SAFETY RECALL NOTICE

Re: Rearview mirrors lenses may dislodge - Decreased visibility - Revision of Vehicles Involved

Campaign no.: 2022-0019
[▶ 2023-0009 ◀](#)

[REVISION ▶ 3](#)
[May 11, 2023 ◀](#)

2. Gently pry open the plastic trim to allow reading the molding batch date code inside the housing.

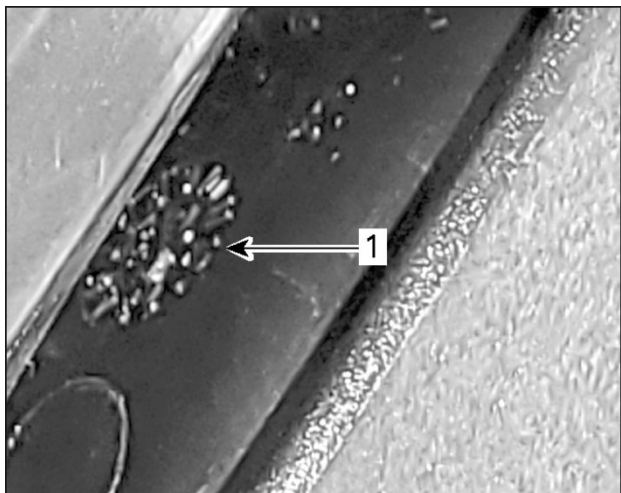
► To inspect the mirror housing, verify its molding batch date code. The date code is located inside the mirror housing. Both mirrors have to be inspected.

1. Carefully insert two spacers into the mirror housing slot.

1. Validate molding date code.

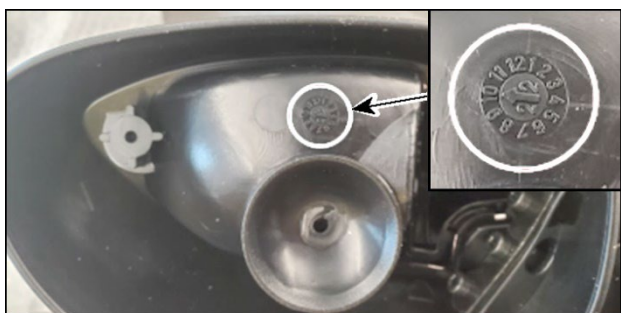
3. Use a magnifying glass to ease reading or take a picture of the molding date code to confirm reading.

To read the date code, the center section indicates the year and the arrow points out to the month on the larger diameter.

4. If molding batch date code is 11/22 or prior, replace both mirror housing assemblies, otherwise mirror housing assembly is good.

MIRROR ASSEMBLY REPLACEMENT (MY23 - if needed, MY22 - mandatory)

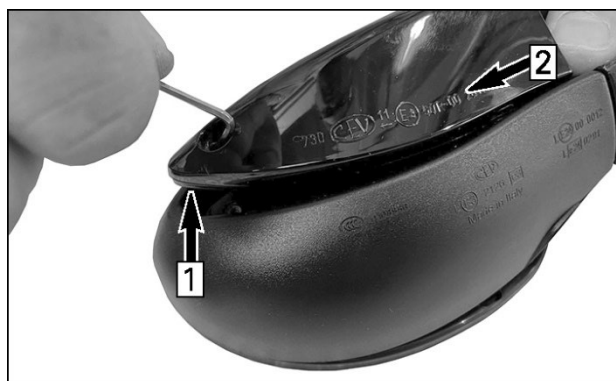
1. Remove and discard the mirror housing cap retaining screw.

2. Gently lift the mirror cap using a small Allen Key, then push the cap out of location as shown on picture to remove it from assembly. Discard the cap.

- Using a 3mm Allen Key, remove and discard the three (3) socket head screws and metal plate.

- Remove and discard the defective mirror assembly.
- Install new mirror assembly and secure in place using the three (3) new socket head screws and new plate from the kit.

TIGHTENING TORQUE	
Mirror Assembly	2.5 N•m ± 0.5 N•m (22 lbf•in ± 4 lbf•in)
Retaining Screw

Vehicles with mirror housing assembly WITH light integrated

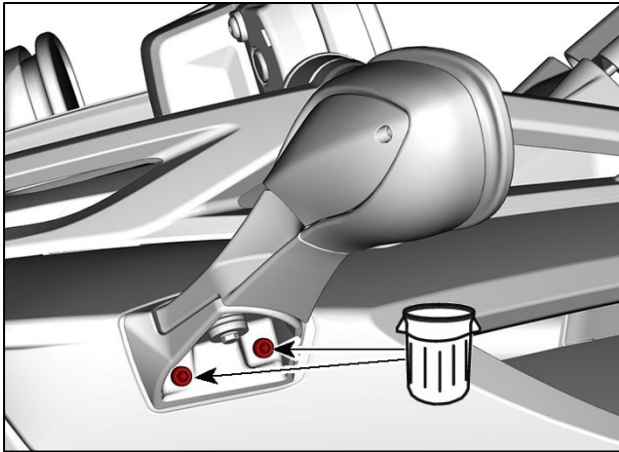
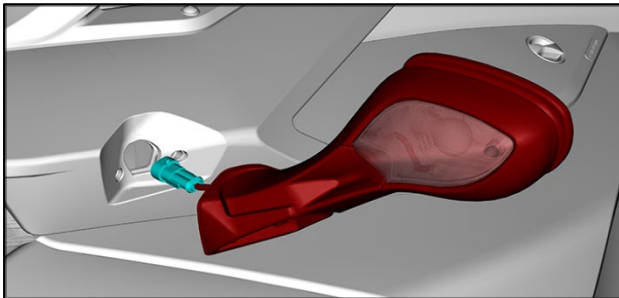
1. Remove and discard the two housing retaining screws.

2. Gently pull the mirror housing and disconnect the mirror light harness connector.

3. Discard the mirror housing assemblies.
4. Clean threads on vehicle.
5. The installation is the reverse of the removal procedure.

TIGHTENING TORQUE	
Mirror Housing Retaining Screw	3.5 N•m ± 0.5 N•m (31 lbf•in ± 4 lbf•in)
